Subject: FUTURE - change of taping dimension

**Packing specification change of M0530LP
[Part No.: ETQP3M[][][]KVP]**

**Jan 10th, 2021
Device Solutions Business Division
Industrial Systems Company
Panasonic Corporation**

Packing specification change of M0530LP

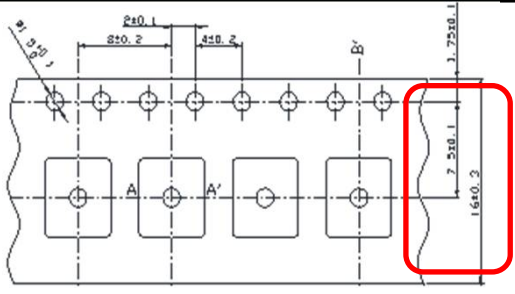
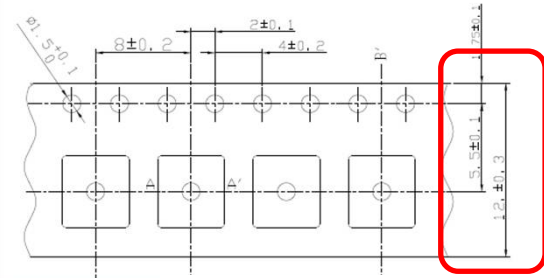
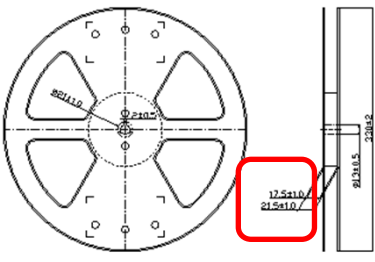
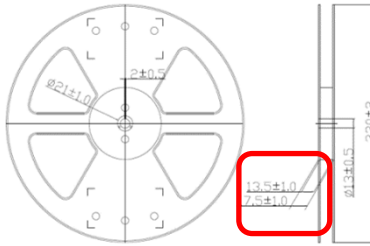
Purpose : Standardization of packaging

This change is only the tape width, the number of stuffing and the direction are not changed.

Before	After
Carrier tape	 <p>7.5mm / 16.0mm</p>	 <p>5.5mm / 12.0mm</p>
Reel dimension	 <p>17.5mm / 21.5mm</p>	 <p>13.5mm / 17.5mm</p>
Packaging dimension	 <p>H: 55mm</p>	 <p>H: 47mm</p>
